UNITED STATES  
NUCLEAR REGULATORY COMMISSION  
WASHINGTON, D.C. 20555-0001

SUBJECT: NINE MILE POINT NUCLEAR STATION, UNITS 1 AND 2 - STAFF ASSESSMENT OF INFORMATION PROVIDED PURSUANT TO TITLE 10 OF THE *CODE OF FEDERAL REGULATIONS* PART 50, SECTION 50.54(f), SEISMIC HAZARD REEVALUATIONS FOR RECOMMENDATION 2.1 OF THE NEAR-TERM TASK FORCE REVIEW OF INSIGHTS FROM THE FUKUSHIMA DAI-ICHI ACCIDENT (TAC NOS. MF3973 and MF3974)

STAFF ASSESSMENT BY THE OFFICE OF NUCLEAR REACTOR REGULATION  
RELATED TO SEISMIC HAZARD AND SCREENING REPORT  
NINE MILE POINT NUCLEAR STATION, UNITS 1 AND 2  
DOCKET NOS. 50-220 AND 50-410

Figure 3.3-1 Plot of Staff's and Licensee's Base Case Shear-Wave Velocity Profiles for the NMP site

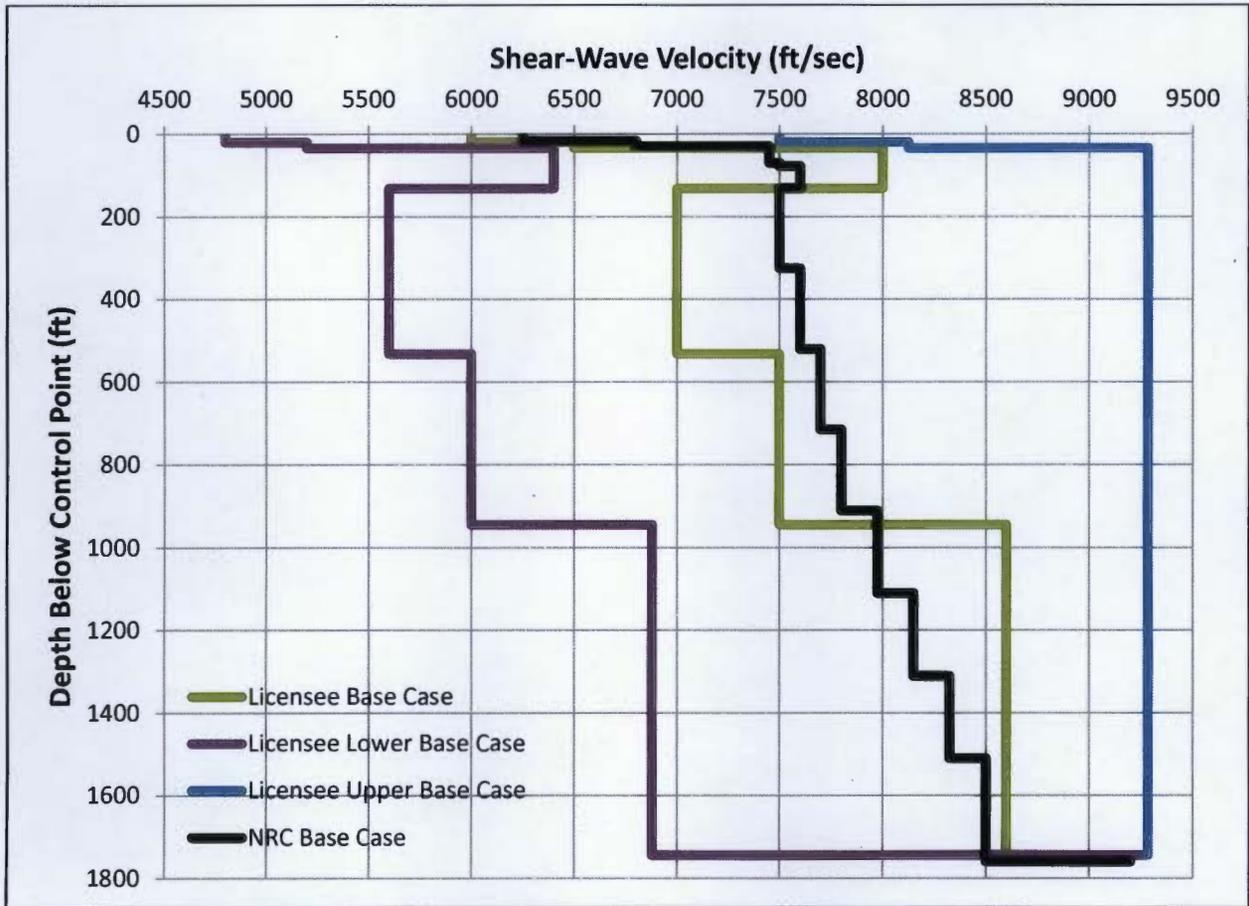
To characterize the subsurface geology, the licensee developed three site base case profiles. The middle, or best estimate, profile was developed using measured shear-wave velocity from nearby cross-hole geophysical investigations. The licensee determined the shear wave velocities for the upper 325 ft [99 m] of rock from measurements near NMP Unit 2, and it determined the velocities for the deeper rock units from measurements at the proposed NMP Unit 3. Upper and lower base case profiles were developed using a natural log standard deviation of 0.18. Figure 3.3-1 of this assessment shows the licensee's three shear-wave velocity base case profiles.

Because the site is well characterized and the velocities reported in the NMP Unit 2 FSAR (Constellation, 2012) and the proposed NMP Unit 3 SAR (UniStar, 2009) are similar, the staff used only a single shear wave velocity profile rather than the three profiles used by the licensee. For the depth interval between the control point and 200 ft [61 m] below the control point, the staff used an average of the measured shear wave velocities at NMP Unit 2 and the proposed NMP Unit 3 for its shear wave velocity profile. For depths between 200 ft [61 m] below the control point and the base of the profile, the staff used the shear wave velocities from the proposed NMP Unit 3. To capture the uncertainty in the depth to base rock, the staff used a value of  $\pm 150$  ft [ $\pm 46$  m], which is considerably less than the  $\pm 524$  ft ( $\pm 160$  m) depth to base rock randomization used by the licensee. Figure 3.3.-1 of this assessment shows the staff's velocity profile compared to the base case profiles developed by the licensee.

Figure 3.3-2 Plot Comparing the Staff's and the License's Median Amplification Functions and Uncertainties for two input loading levels for the NMP site

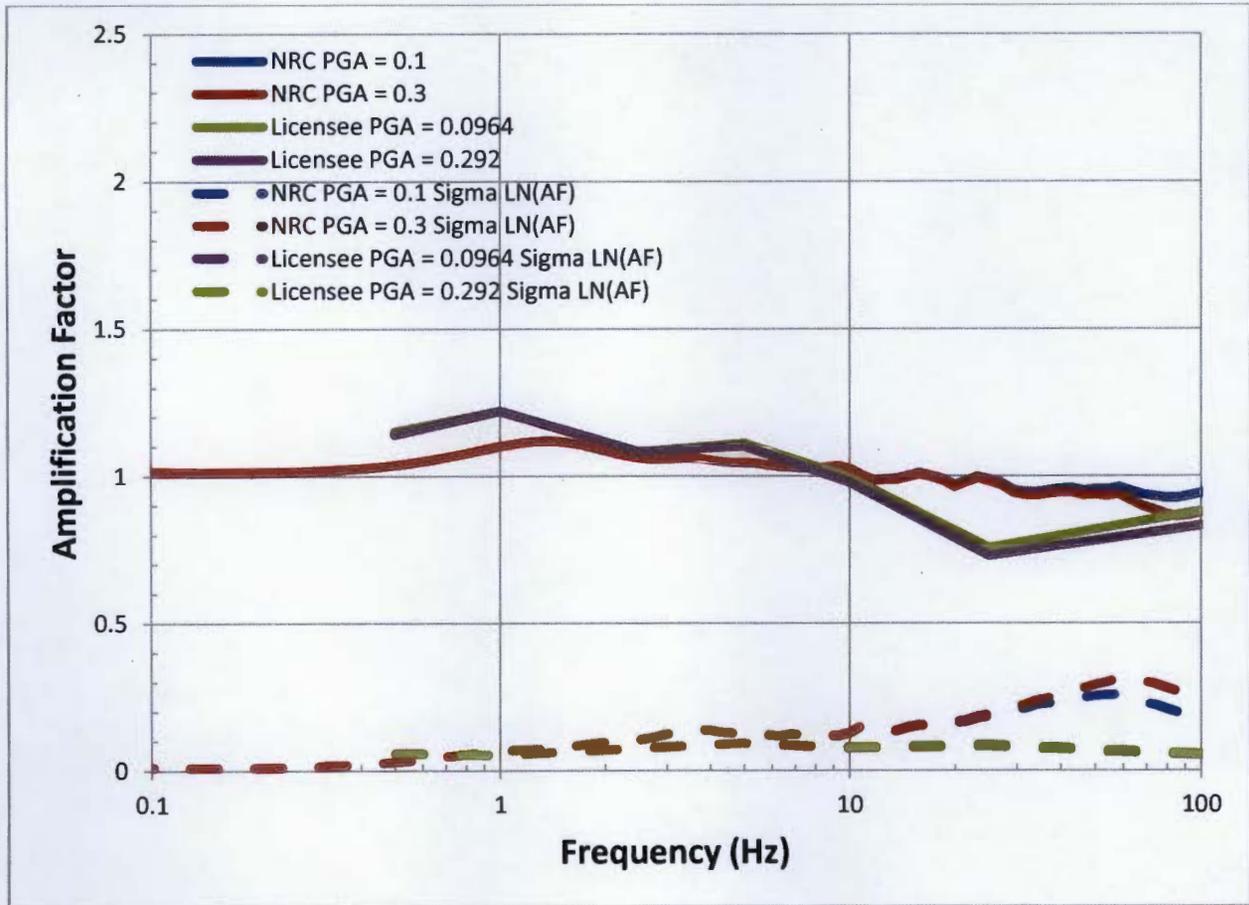
Figure 3.3-2 of this assessment shows a comparison of the staff's and licensee's median site amplification functions and uncertainties ( $\pm 1$  standard deviation) for two of the eleven input loading levels. Due to the use of very low damping values and modeling of the rock behavior as essentially linear for the range of input loading levels, the staff's confirmatory amplification factors are essentially one for the entire frequency range. Above approximately 10 Hz, amplification functions calculated by the licensee are lower than those developed by the staff due to the greater nonlinearity included in the licensee's analyses.

The staff conducted sensitivity tests to evaluate the licensee's use of (1) multiple base case velocity profiles, (2) higher damping values and the assumption of more nonlinearity over a larger portion of the subsurface profiles, (3) higher kappa values, and (4) a large depth to base rock randomization value. Of these four factors, the higher damping values (3 percent and higher), which the licensee used for the upper 500 ft [152 m] of the rock profile, resulted in the largest difference in the sets of amplification factors developed by the licensee and staff. These differences are shown in Figure 3.3-2 of this assessment for frequencies above 10 Hz.

Figure 3.3-3 Plot Comparing the Staff's and the Licensee's Mean Control Point Hazard Curves at a Variety of Frequencies for the NMP site

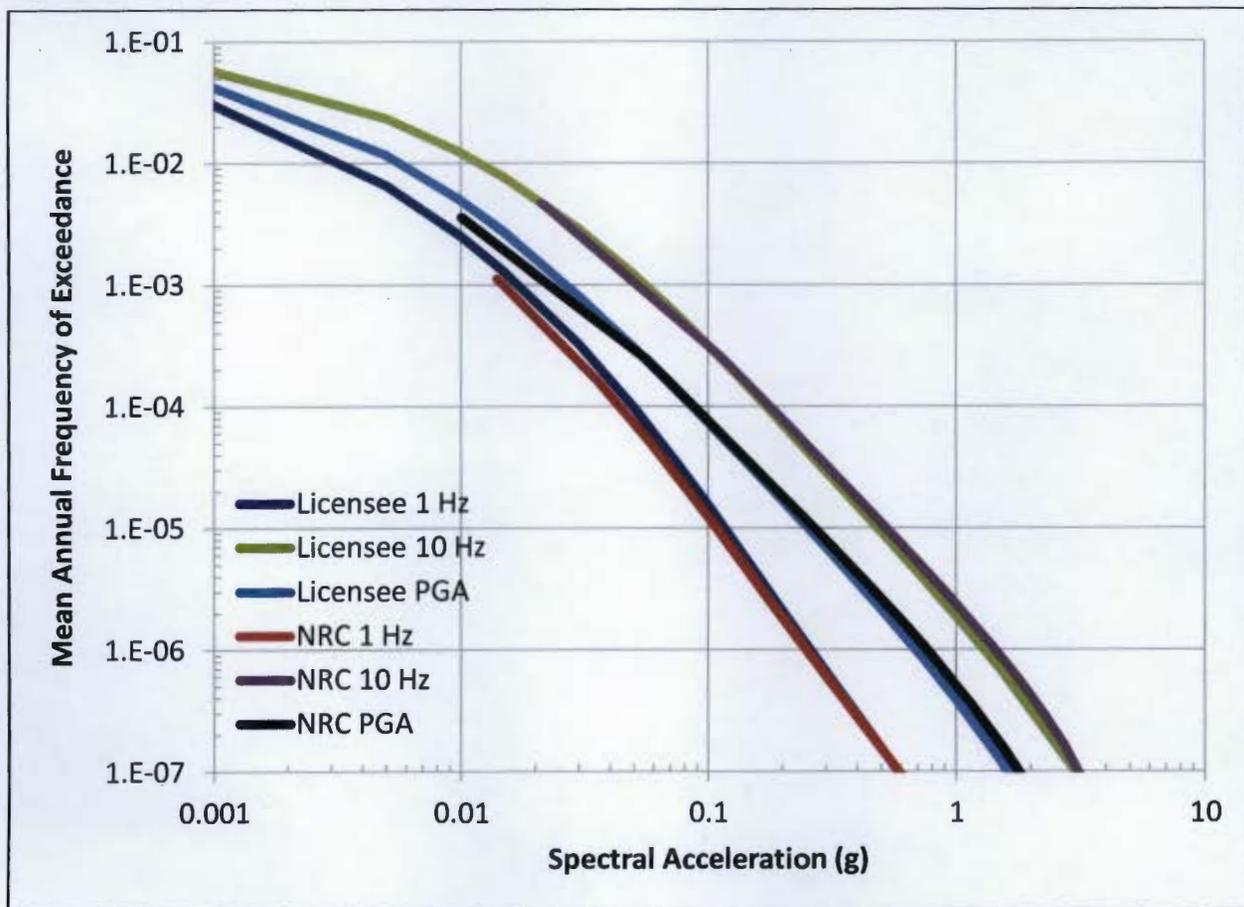
Overall, the licensee’s approach to modeling the subsurface rock properties and their uncertainties results in slightly lower site amplification factors relative to the staff’s results, particularly at high frequencies. However, as shown in Figure 3.3-3 of this assessment, these differences in the site response analysis do not have a large impact on the control point seismic hazard curves or the resulting GMRS, as discussed below. Appendix B of the SPID provides guidance for performing site response analyses, including capturing the uncertainty for sites with less subsurface data; however, the guidance is neither entirely prescriptive nor comprehensive. As such, various approaches in performing site response analyses, including the modeling of uncertainty, are acceptable for this application.

Figure 3.4-1 Comparison of the Staff's GMRS with Licensee's GMRS and the SSEs for NMP Unit 1 (Red) and NMP Unit 2 (Red dashed).

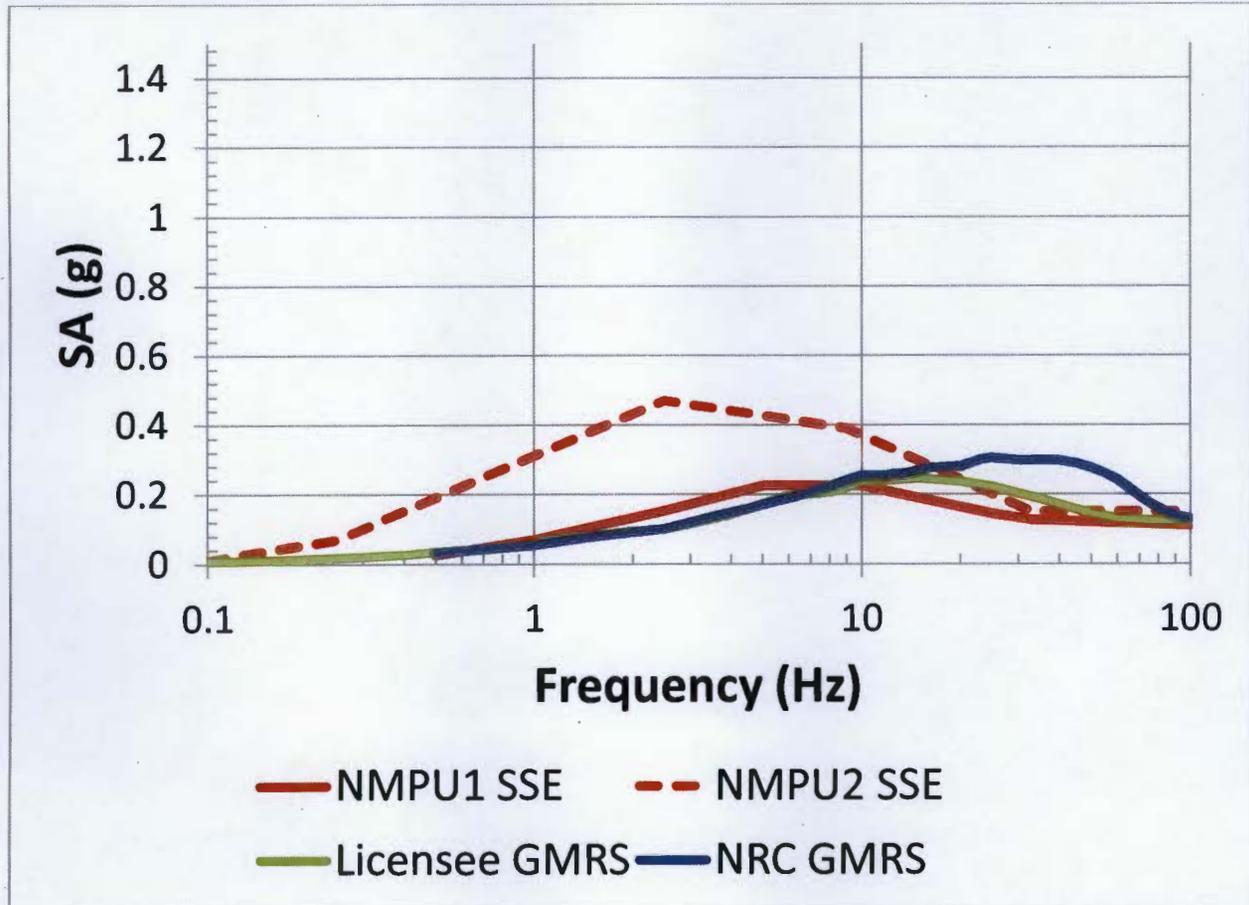
The staff independently calculated the  $10^{-4}$  and  $10^{-5}$  UHRS using the results of its confirmatory PSHA and site response analyses, as described in Sections 3.2 and 3.3 of this staff assessment, respectively. Figure 3.4-1 of the assessment shows a comparison of the GMRS determined by the licensee to that determined by the staff.

As shown in Figure 3.4-1 below, the licensee’s GMRS shape is generally similar to that calculated by the staff at frequencies less than 10 Hz. However, NRC staff’s confirmatory GMRS is somewhat higher than the licensee’s at frequencies above 10 Hz. As described above in Section 3.3, the staff concludes that these minor differences over the higher frequency range are primarily due to the differences in the site response analyses performed by the licensee and staff. The staff concludes that these differences are acceptable for this application because the licensee followed the guidance provided in the SPID with respect to both the PSHA and site response analysis for the NMP site.
